Staff Report & Recommendation

Historic Preservation Board

SUBJECT: HPB23-0575, **100 Block of Lincoln Road Right-of-Way and 1 Lincoln Road.**

An application has been filed requesting a Certificate of Appropriateness for improvements to Lincoln Road between Collins Avenue and the Beachwalk.

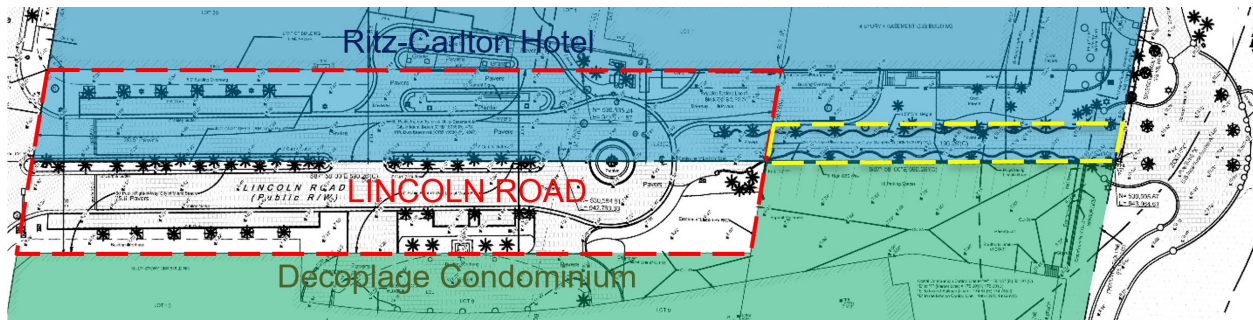
Staff would preface this analysis by noting the unique ownership conditions of the portion of Lincoln Road east of Collins Avenue. As can be seen in the diagram below, the northern half of what is recognized as Lincoln Road (red) is actually part of the Ritz-Carlton Hotel property (blue). Additionally, the northeastern corner of the Decoplage Condominium (green) property extends north to meet the Ritz-Carton property. In order to provide access to the Beachwalk, the City has a 20'-0" wide pedestrian access agreement (yellow) within the southwestern corner of the property.

The subject application is limited to improvements to Lincoln Road (including the portion owned by the Ritz-Carlton and the pedestrian easement area (the areas outlined in red and yellow). Improvements include the reconfiguration of the roadway and sidewalks, the introduction of decorative paving and enhanced landscaping. Additionally, the applicant is proposing to modify the Ritz-Carlton Hotel drop off area including the widening of the pedestrian walkway along this portion of the building and the introduction of a new driveway and loading area configuration. Staff would note that as part of a separate application (HPB23-0574), the application is also proposing the introduction of a new porte-cochere to provide protection for the proposed drop off area.
